Safety Recall

N242448540 Right Front Lower Control Link Fracture

Revision: 01

Revision Description: This bulletin has been revised to provide the final remedy procedure, floor plan reimbursement, and the customer notification letter. Please discard all previous copies of bulletin N242448540.

6681186

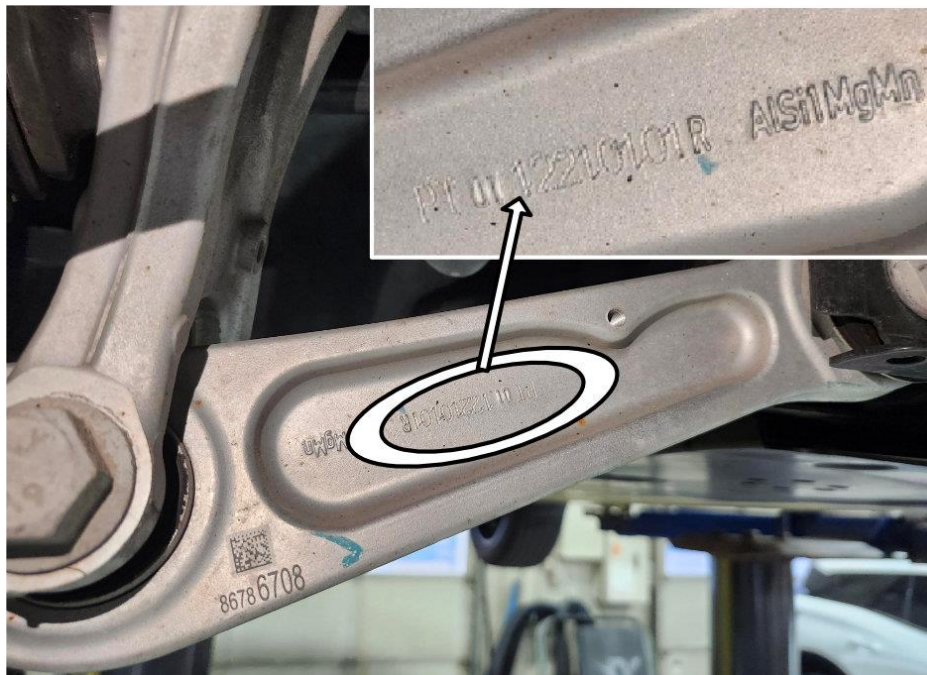
Note: The lot number will be upside down when installed on the vehicle. Use a mobile camera to take a photo of the lot number to read the lot number more easily if necessary.

1. Inspect the RH side Front Lower Control Front Link Lot Number on the vehicle.
 - If the lot number is 12312261, proceed to step 2.
 - If the lot number is NOT 12312261, no further action is required.
2. Replace the RH side Front Lower Control Front Link. Refer to *Front Lower Control Front Link Replacement* in SI.
